ERRATA SHEET

Date: 2008 Nov 07
Document Release: Version 1.2
Device Affected: P89LPC920

Figure 1: Flowchart ICP Global Erase

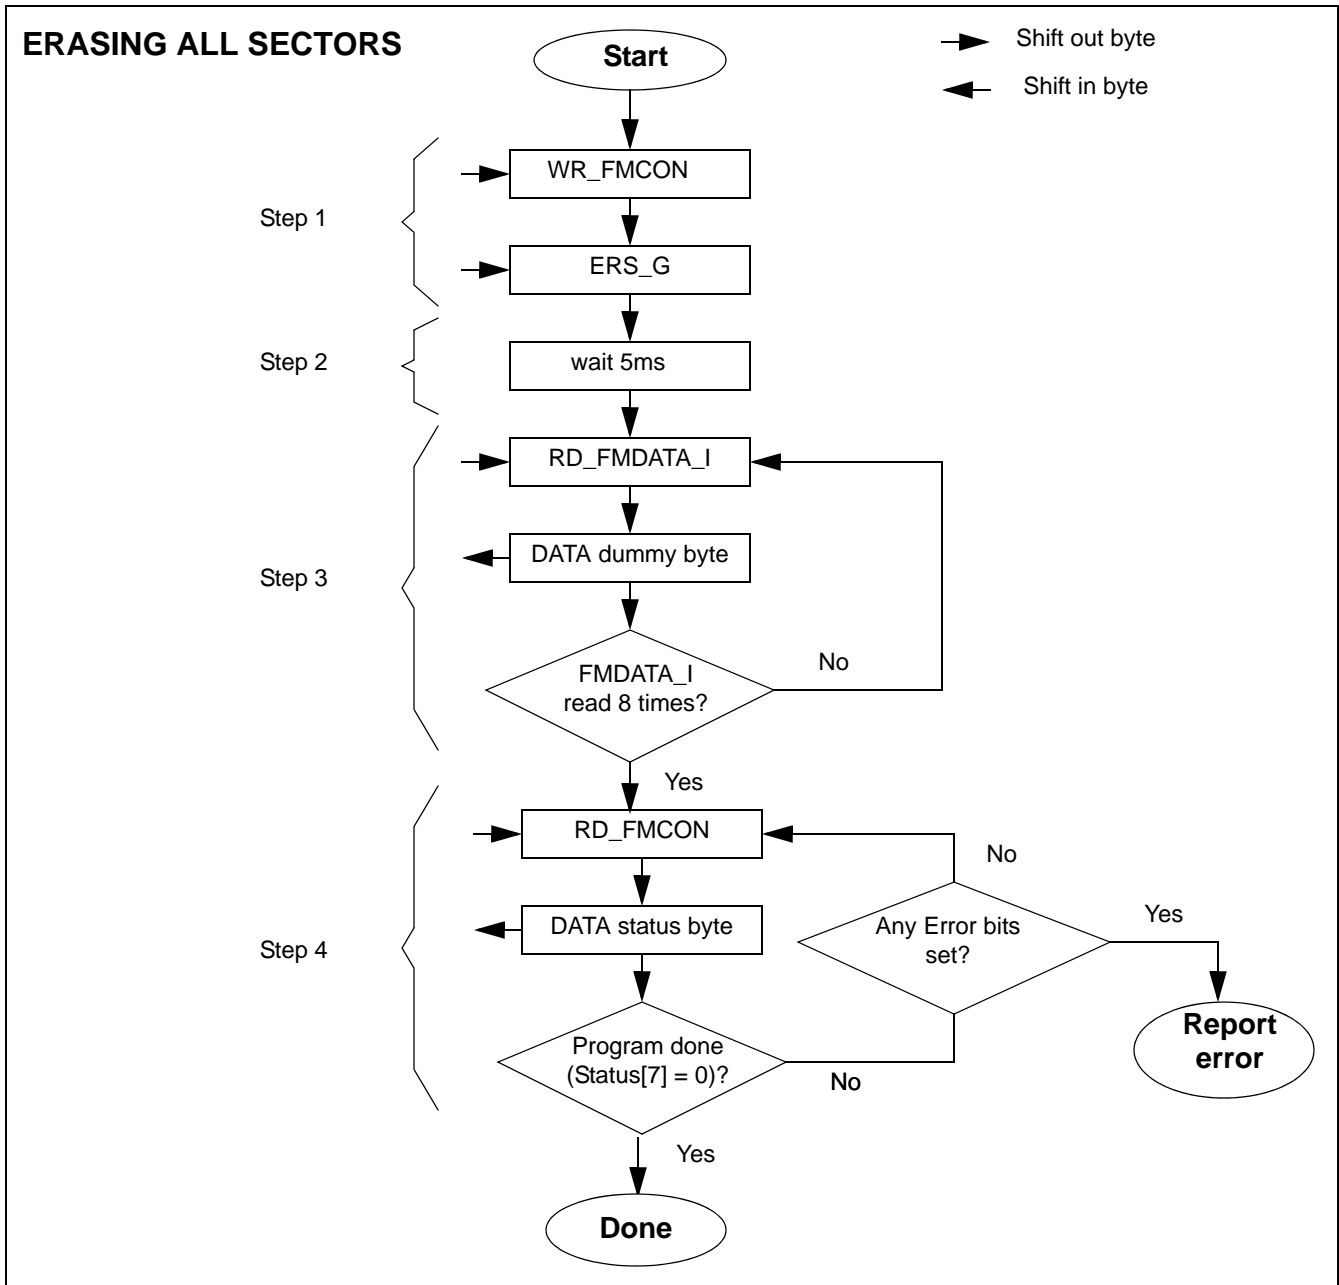
ICP.1: ICP Global Erase

Introduction: The LPC920 can be programmed using ICP (In Circuit Programming). One of the ICP functions is the Erase Global command, which will erase the entire chip including the security bytes and configuration information.

Problem: When giving the Erase Global command through the ICP interface the LPC920 will not clear the busy flag and stay busy forever.

Workaround: The workaround can be done in 4 steps:

Step 1: Shift out the WR_FMCON command followed by the Erase Global opcode.

Step 2: Wait 5ms.

Step 3: Do 8 dummy reads with the RD_FMDATA_I command.

Step 4: Read FMCON until the busy flag gets cleared.

Please also see figure 1 on the following page.
